Well Name: POKER LAKE UNIT 13-24 PC	Well Location: T24S / R29E / SEC 13 / SWNE /	County or Parish/State:
Well Number: 116H	Type of Well: CONVENTIONAL GAS WELL	Allottee or Tribe Name:
Lease Number: NMNM005912	Unit or CA Name:	Unit or CA Number: NMNM71016X
US Well Number: 3001553557	Well Status: Approved Application for Permit to Drill	Operator: XTO PERMIAN OPERATING LLC

Procedure Description: **Surface hole Change, First and Last Take Point Changes, Bottomhole Location Change, Drilling Plan Change, Casing/Cement Change XTO Permian Operating, LCC. requests permission to make the following changes to the original APD: No Additional Surface Disturbance SHL: fr/2384’FNL & 2145’FEL to 2459’FNL & 2280’FEL, NMNM05912 FTP: fr/2740’FNL & 1650’FEL to 1959’FNL & 1656’FEL, NMNM05912 LTP: fr/330’FSL & 1650’FEL to 2318’FSL & 1656’FEL, NMLC0696005A BHL: fr/200’FSL & 1650’FEL to 2368’FSL & 1656’FEL, Section 1-T24S-R29E NMLC0696005A Additionally, XTO Permian Operating, LLC. respectfully requests permission to upsize the surface, intermediate and production hole, casing, and cement based on the attached drilling program. Due to the upsize in these strings, the wellhead configuration has also changed

WELL LOCATION AND ACREAGE DEDICATION PLAT

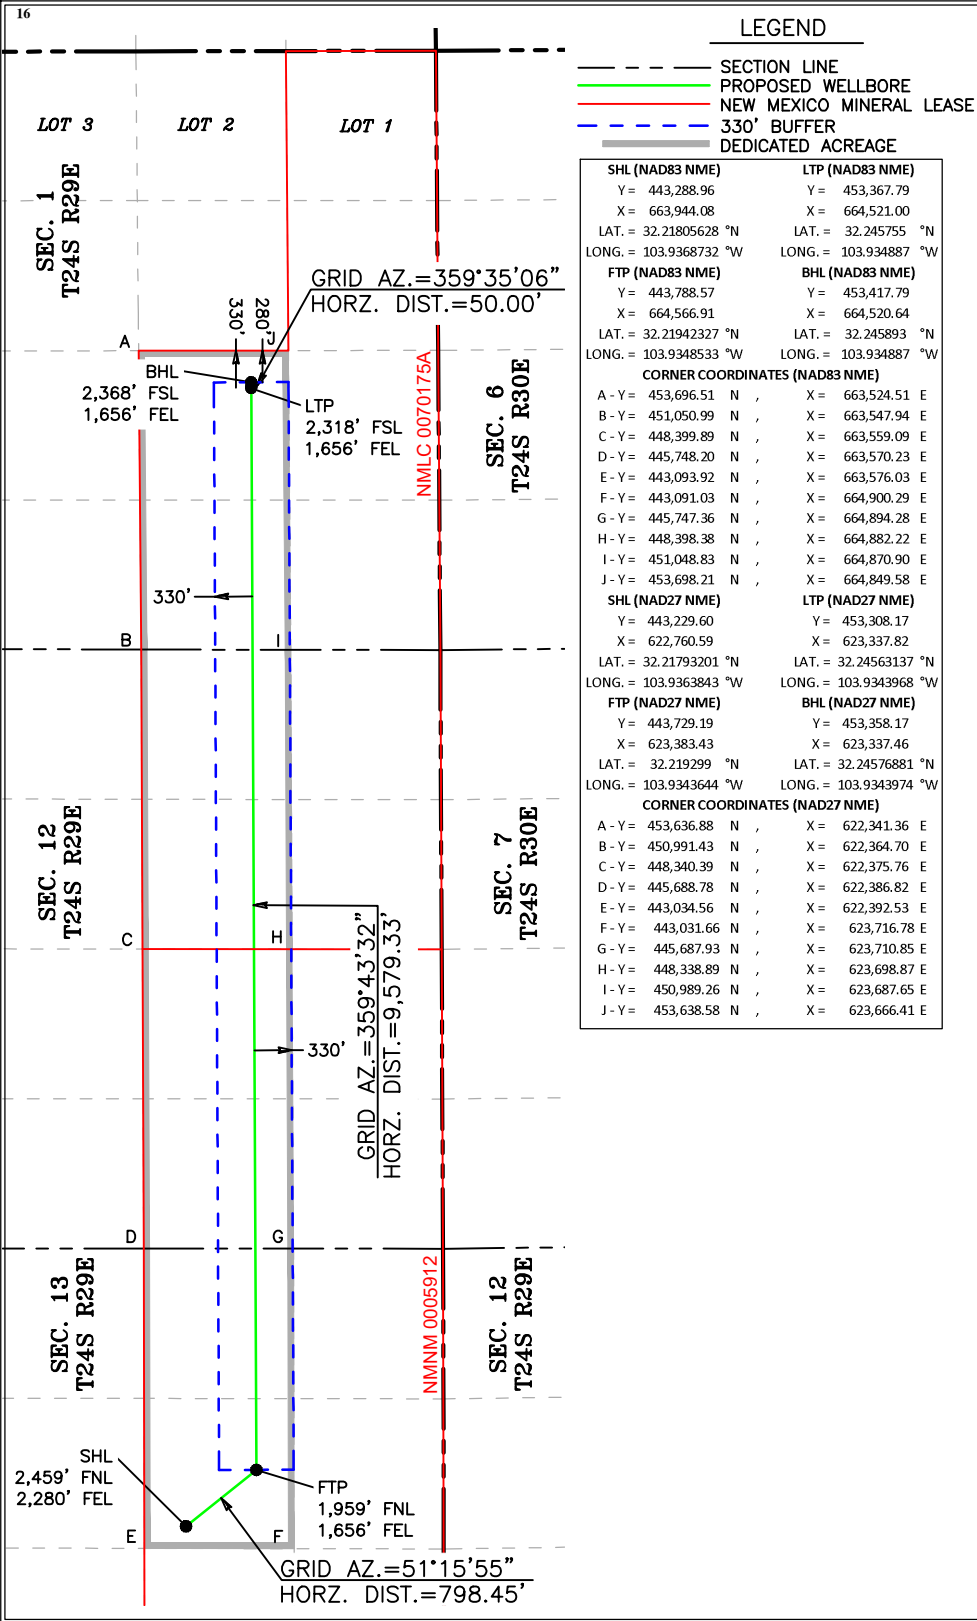
SHL: fr/2384FNL & 2145FEL to 2459FNL & 2280FEL, NMNM05912

FTP: fr/2740FNL & 1650FEL to 1959FNL & 1656FEL, NMNM05912

LTP: fr/330FSL & 1650FEL to 2318FSL & 1656FEL, NMLC0696005A

BHL: fr/200FSL & 1650FEL to 2368FSL & 1656FEL, Section 1-T24S-R29E NMLC0696005A

PROPOSED HSU IS NOT APPROVED - Dean McClure

Created By	Condition	Condition Date
dmcclure	The Proposed HSU is NOT approved. In the event that a NSP is granted for the proposed HSU, the operator shall submit a change of plans to amend the standard HSU to the non-standard HSU approved in the NSP.	3/10/2025
dmcclure	If cement is not circulated to surface during cementing operations, a Cement Bond Log (CBL) is required.	3/10/2025
